Assumption Change Control Sheet

Test	2a, 2b. DHW dynamic test
Assumption	20. DHW dynamic draw off duration and duration of pauses

Change Originator	Martin Crane
Change Request No.	038
Date of Request	20/08/2020
Proposed Change to Assumption?	N

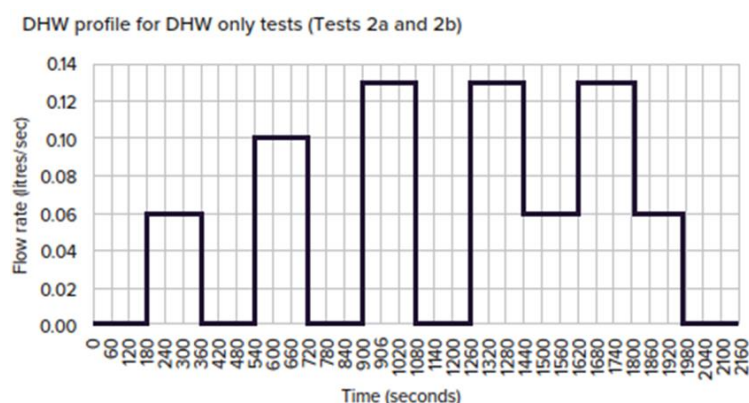
Retain DHW dynamic test pattern:

For the DHW outputs used in the Test, each flow (0.06 l/s (10kW), 0.01 l/s (17kW) and 0.13 l/s (22kW)) is for 180 seconds with a 180 second pause in between. The pattern of flows is shown below.

The return temperature during these 180 second periods are used in the VWARD calculation

- 180 seconds between DHW draw off is long enough for the HIU to stabilise after the DHW demand, giving time for the DH flow rate to drop to zero.
- Data from recent tests show that the DH return temperatures stabilises quickly after the change in DHW flow rate, so increasing or reducing the length of DHW draw off would have little impact on the average return temperatures – which are the inputs to the VWARD calculation.

Current Test methodology provides what seems to be representative data for the VWART calculation and the graphed results show the effectiveness of the HIU control. The Test methodology provides a check that the HIU does not generate high DHW temperature spikes.
